ADDENDUM NO. 2

Date of Addendum: July 29, 2016

PROJECT NAME: Sims North Wastewater Treatment Plant (WWTP) Waste and Debris
Offloading and Disposal Station

PROJECT NO: WBS No. R-000265-0081-4

STORM SEWER PLAN
 SCALE: 1" = 20'

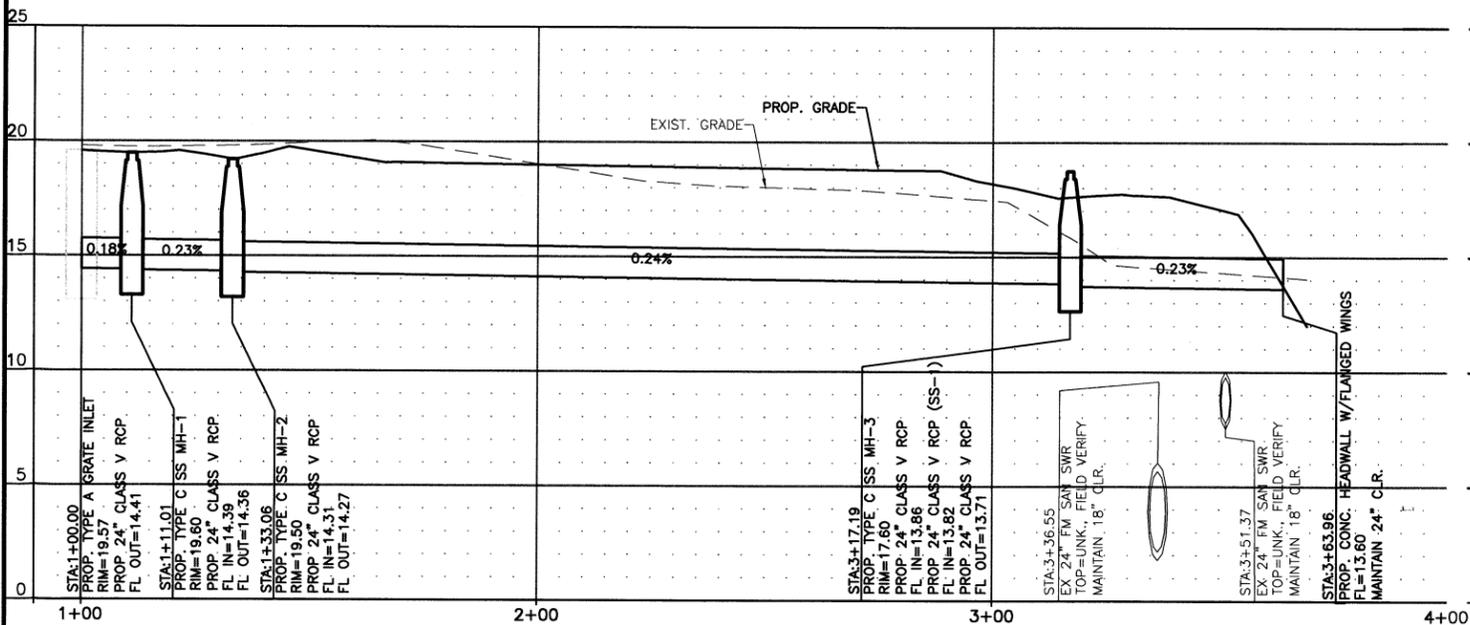
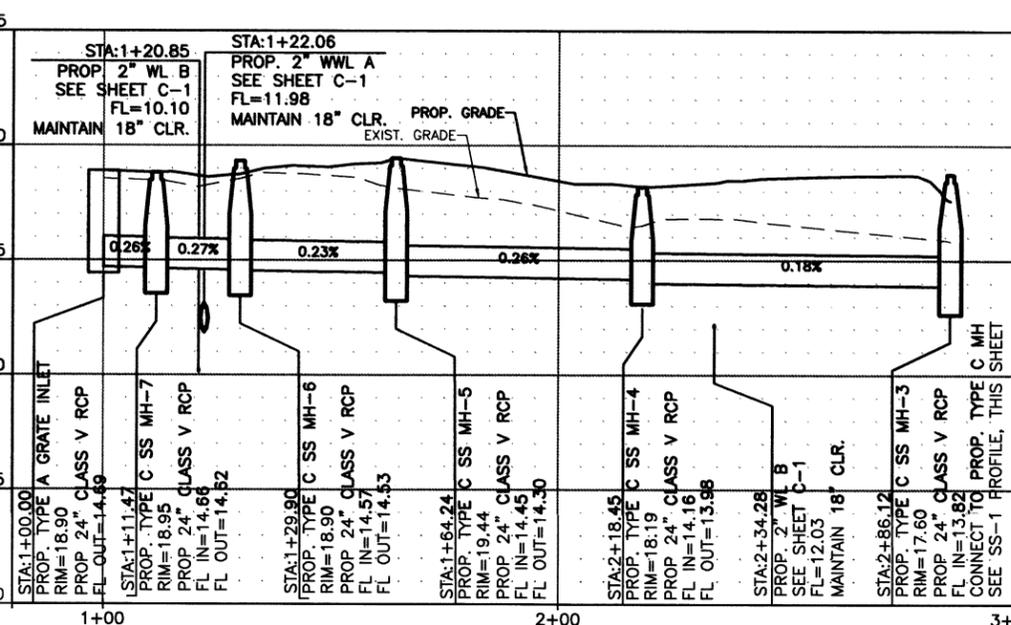
7. Sheet C-4 (Sheet No. 12 of 41) – Storm Sewer Plan & Profile:

Add the following note:

“1. USE CLASS III RCP IN LIEU OF ALL CLASS V RCP SHOWN ON THIS DRAWING.”

NOTES:
 1. USE CLASS III RCP IN LIEU OF ALL CLASS V RCP SHOWN ON THIS DRAWING.

DRAWING SCALE		
3/16"=1'-0"		
CITY OF HOUSTON PM		
Iraj M. Ranjbar, P.E.		
DWG NO.: M-1		
SHEET NO. 15 OF 41

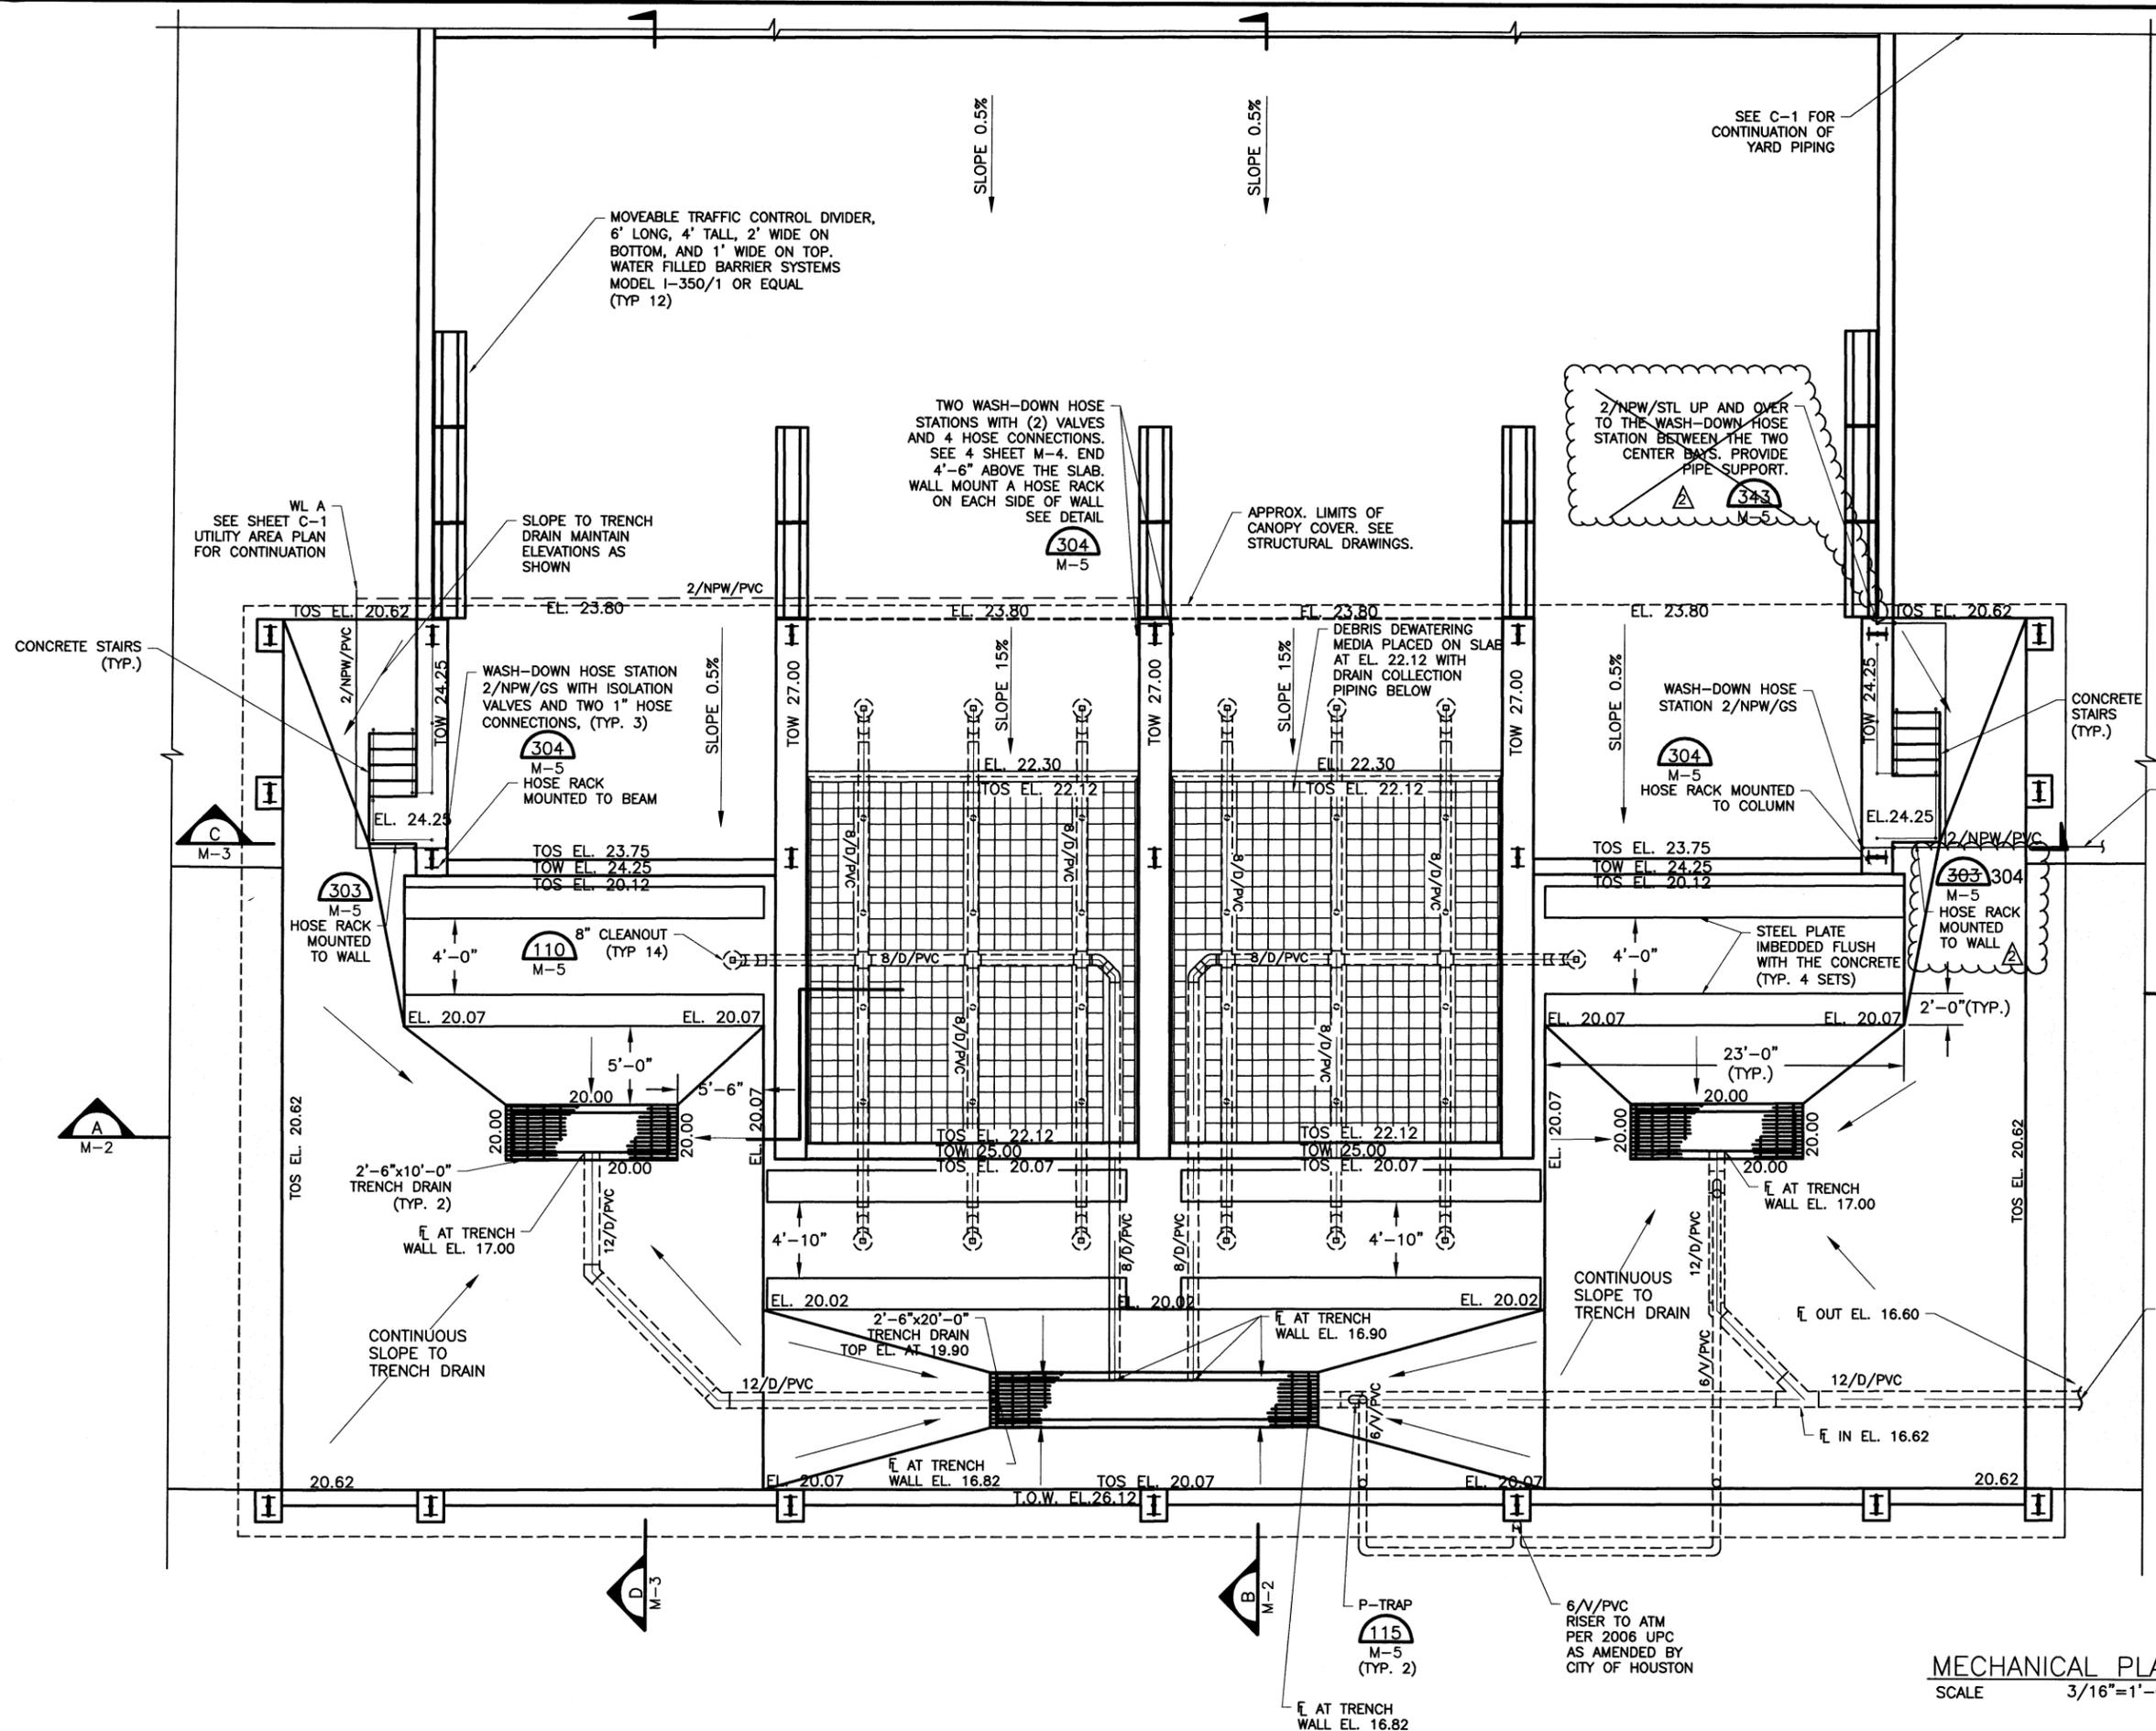
8. Sheet M-1 (Sheet No. 15 of 41) – Filter & Roll-Off Area Mechanical Plan:

Add the following notes:

“3. PROVIDE SYSTEM 108 COATING FOR NEW CONCRETE AS FOLLOWS: COAT THE CONCRETE SLAB BENEATH THE DRAIN TILES AND COAT THE CONCRETE SIDE WALLS UP TO THE TOP OF THE LUMBER PIECES ABOVE THE DRAIN TILES.

4. EMBEDDED PLATES SHALL BE 3/8” THICK.”

Change Detail “303” Callout to Detail “304”.

Delete the following note on the top right corner:

“2/NPW/STL UP AND OVER TO THE WASH-DOWN HOSE STATION BETWEEN THE TWO CENTER BAYS. PROVIDE PIPE SUPPORT, DETAIL 343 SHOWN ON PAGE M-5.”

SECTION A
SCALE: 3/16"=1'-0" M-1

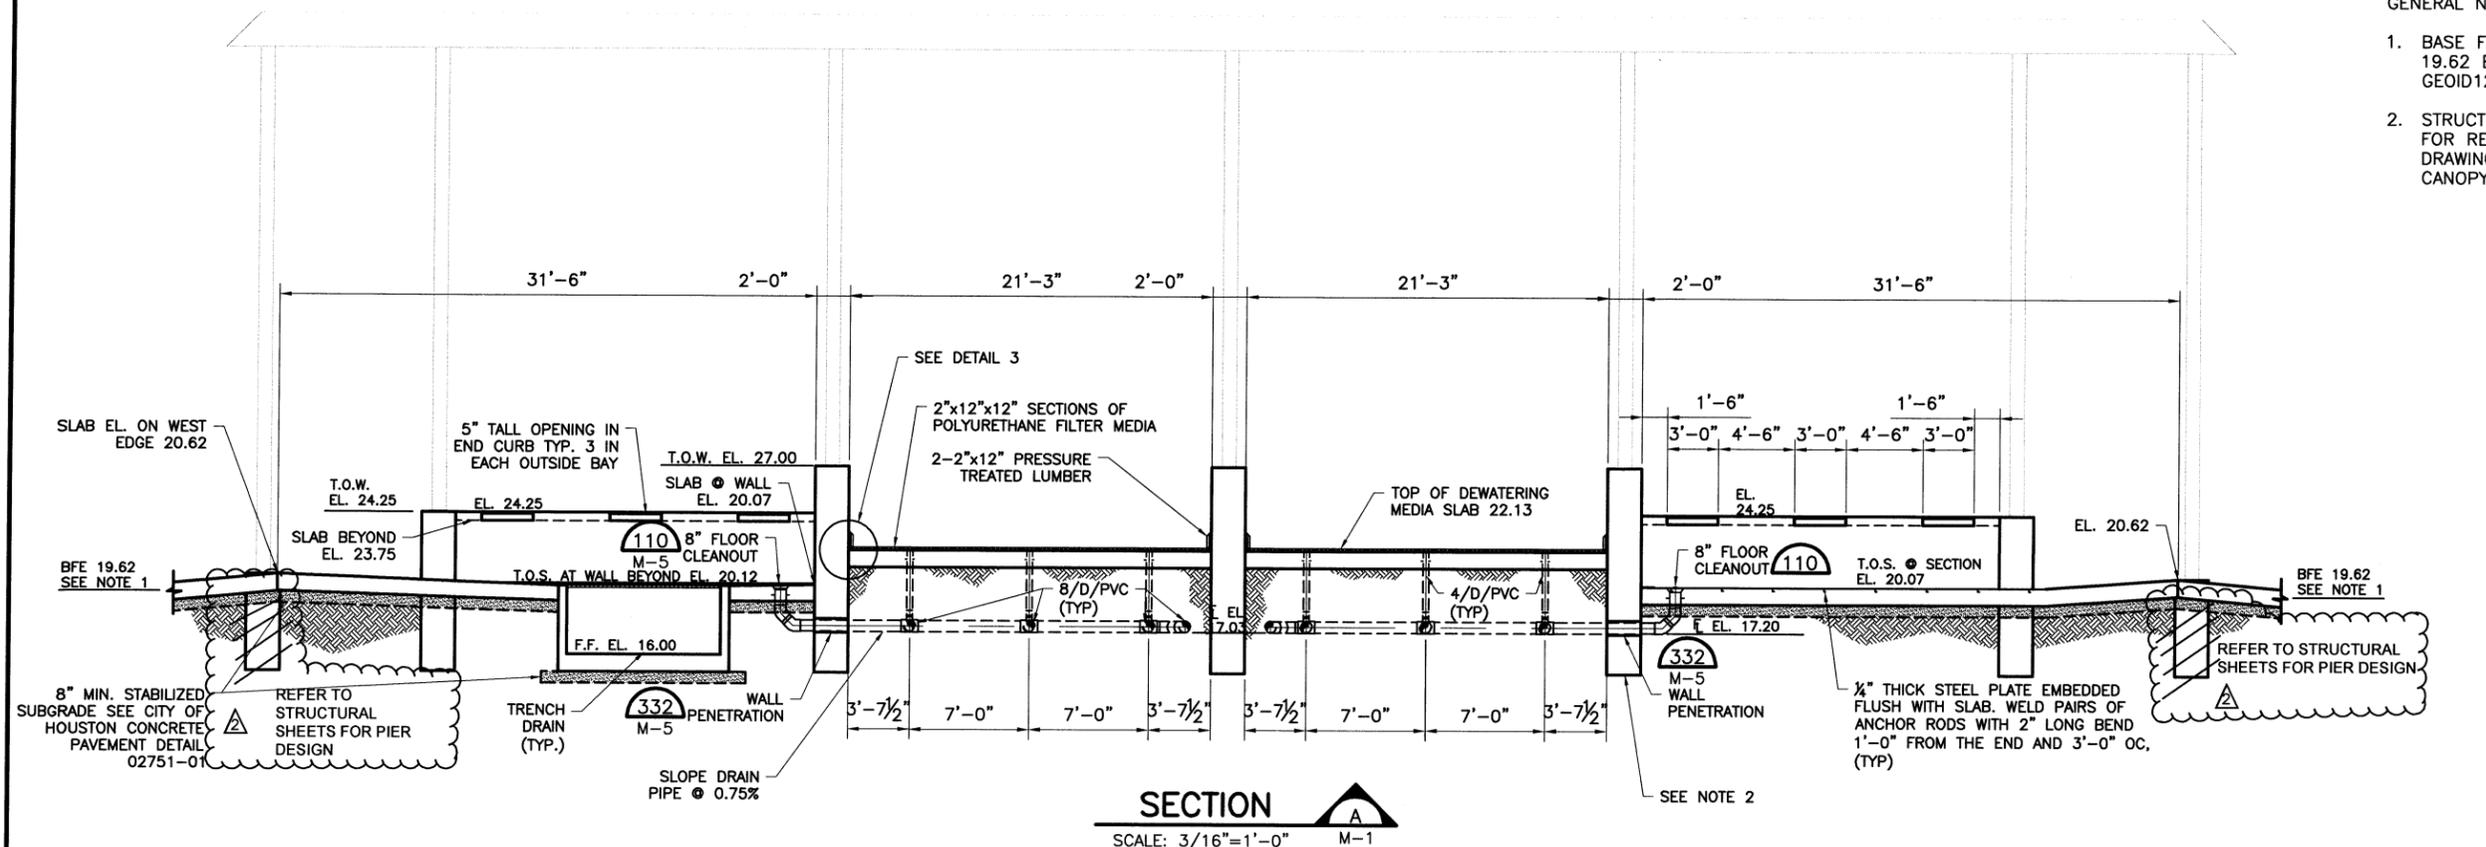
9. Sheet M-2 (Sheet No. 16 of 41) – Filter & Roll-Off Area Mechanical Sections:

SECTION A:

Delete grade beam shown at Column 1. See Structural Sheets for location of Column 1

Delete grade beam shown at Column 7. See Structural Sheets for location of Column 7.

Add the following note at base of Column 1:

“REFER TO STRUCTURAL SHEETS FOR PIER DESIGN.”

Add the following note at base of Column 7:

“REFER TO STRUCTURAL SHEETS FOR PIER DESIGN.”

8" CLEANOUT
NOT TO SCALE (110)

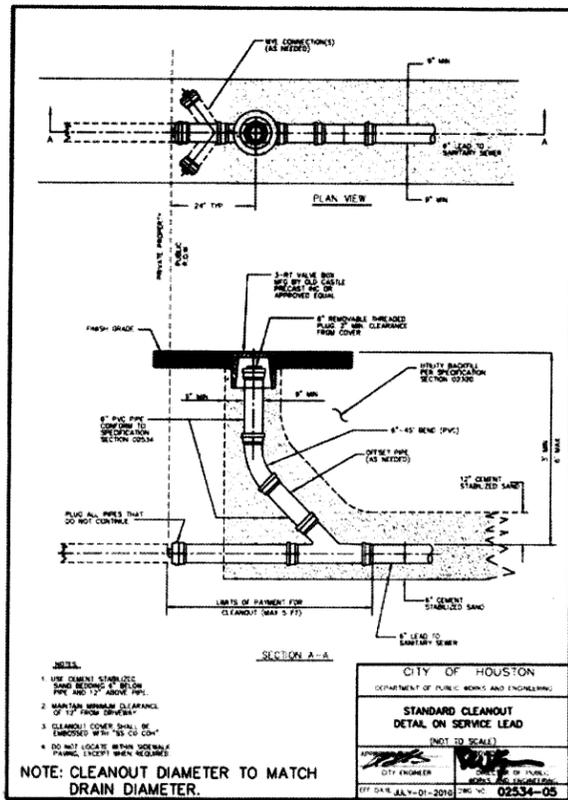
11. Sheet M-5 (Sheet No. 19 of 41) – Mechanical Details

STANDARD CLEANOUT DETAIL ON SERVICE LEAD on the top left corner:

Add Note “DETAIL 110 - “8” CLEANOUT”.

ROOF FRAMING PLAN
 SCALE 1/8"=1'-0"

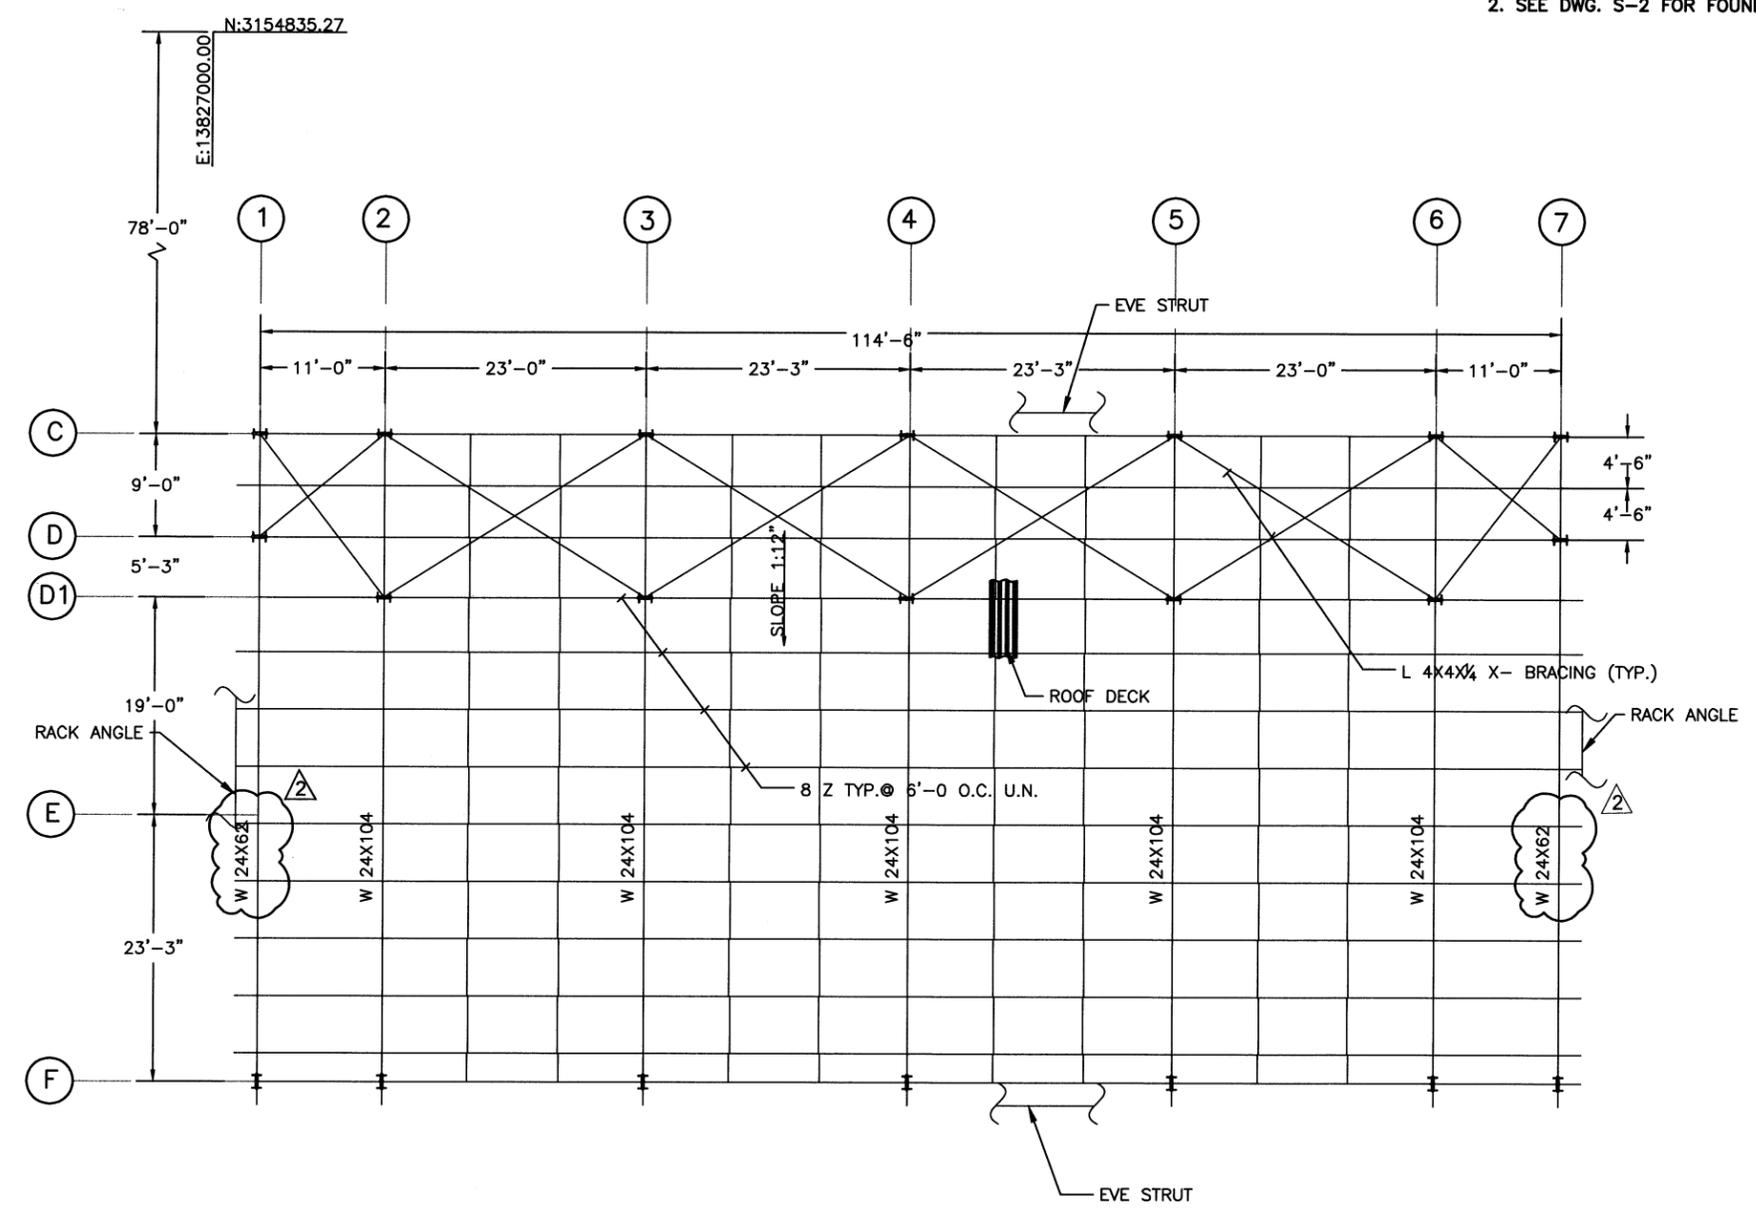
16. Drawing S-6 (sht 25), what is the roof framing running north and south in between column lines 2&3, 3&4, 4&5 and 5&6. How is this framing to be supported? This framing is not shown on drawing S-7 (sht 26)

Response: These are #4 round bars bridging between the z- purlins.

ELEVATION @ COL. 1 & 7

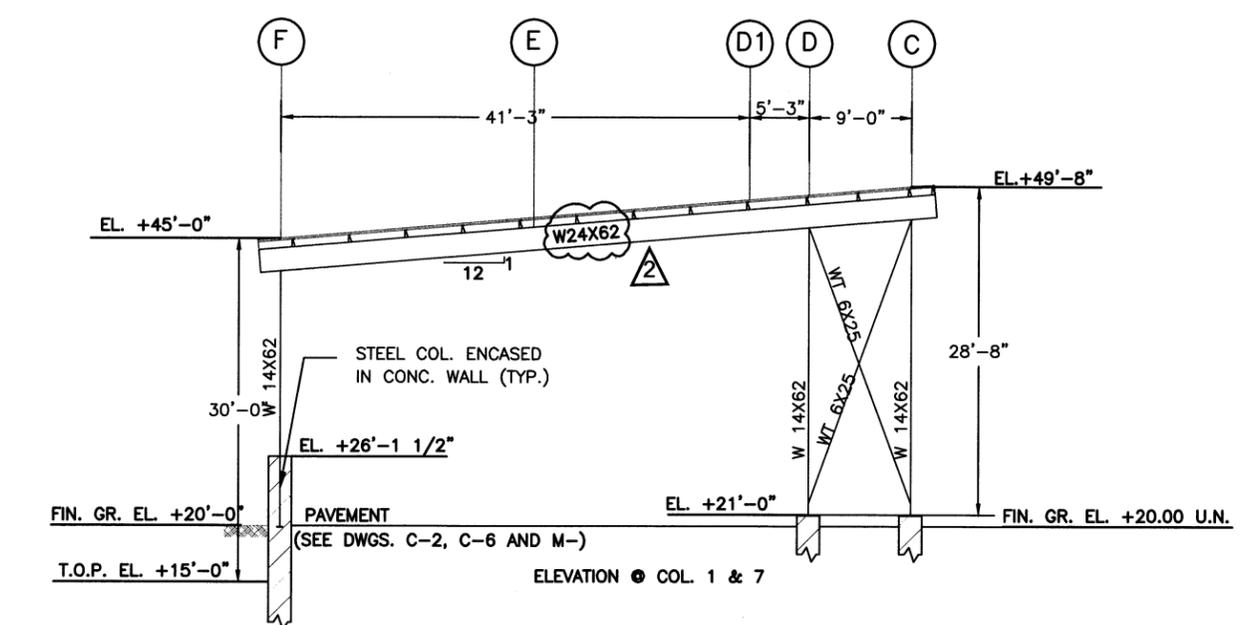
15. Sheet S-8 (Sheet No. 27 of 41) – Transverse Elevations:

ELEVATION @COL. 1&7, below roof:

Change roof beam dimension from “W24x104” to “W24x62”.
